YEAR
1991-92

BULLETIN NO.
92-016

Seat Memory Beeps or Fails to Recall

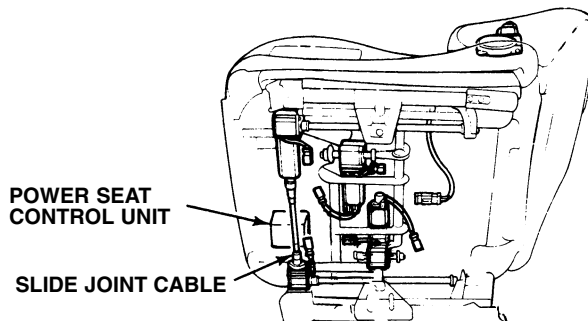
1. Move the seat backward. Remove the front seat track covers and mounting bolts.
2. Move the seat forward. Remove the rear seat track covers and mounting bolts.
3. Lift the front of the seat and support it with a 10 in. long piece of wood.
4. Remove the two mounting screws and the front cover.
5. Remove the slide joint cable.

6. Remove the four mounting bolts for the control unit. Disconnect the three electrical connectors and remove the control unit.
7. Connect the electrical connectors to the new control unit. Mount the control unit with the original bolts, tighten them securely.
8. Reinstall the slide joint cable and the front cover.
9. Install the four seat track mounting bolts, tighten them to 35 N·m (3.4 kg·m, 25 lb·ft). Install the seat track covers.
10. Move the seat bottom and seat-back through their full ranges to make sure they do not bind.

Replace the power seat control unit with the appropriate updated unit listed under PARTS INFORMATION.
